RFP #TC-014-20 – Addenda #2  
Design-Build Thorndale Park Fieldhouse  
October 22, 2020

**RFP #TC-014-20 – Addenda #2 – October 22, 2020**

**Design-Build Thorndale Park Fieldhouse**

**Building Location – the follow image is a replacement to Appendix C – site plan.**

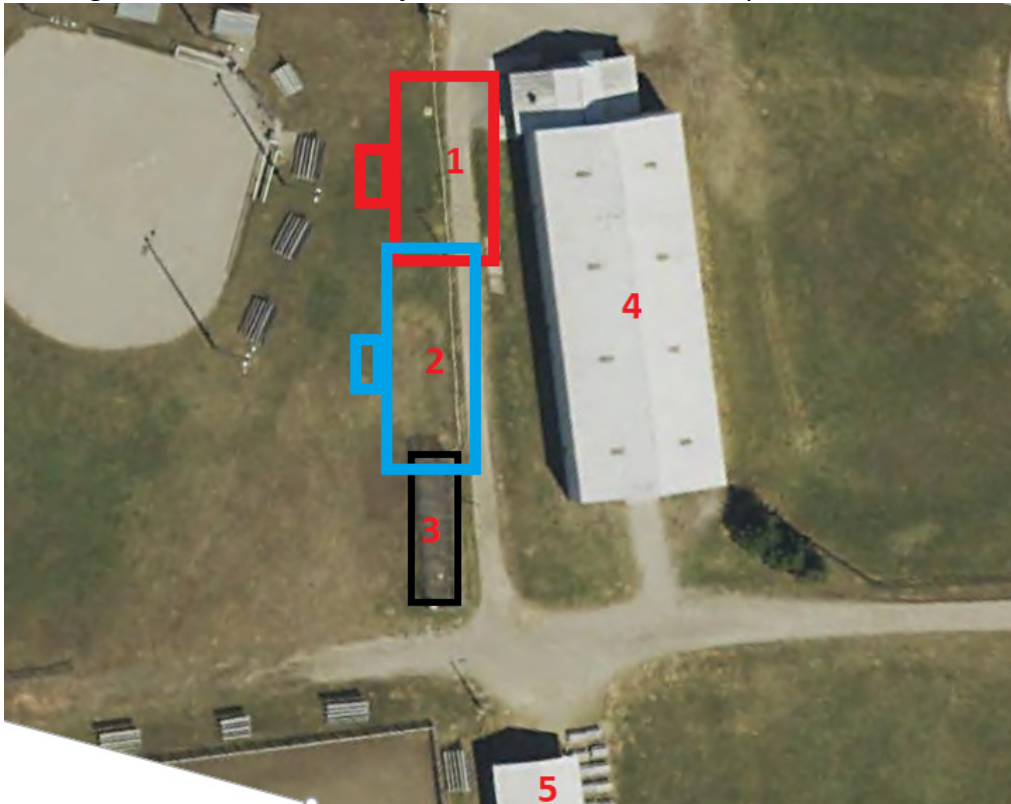
- 1 – the red outline in below site plan (with the red “1”) is the location shown in Appendix C of the RFP, this location is no longer correct/accurate.
- 2 – the blue outline in below site plan (with the red “2”) is the correct approximate location for the fieldhouse (but will run more parallel with the cement slab behind the building). The winning proponent will stake-out the exact footprint for municipal approval before proceeding.
- 3 – the black outline below (with the red “3”) is the location of the current batting cage.
- 4 – the red “4” in below site plan shows the roof of the former Progress Building. This building is no longer in place, all that remains here is the cement pad.
- 5 – the red “5” in below site plan shows a portion of the roof of the pavilion/picnic shelter where the mandatory site meeting was held, shown here just for another reference point.
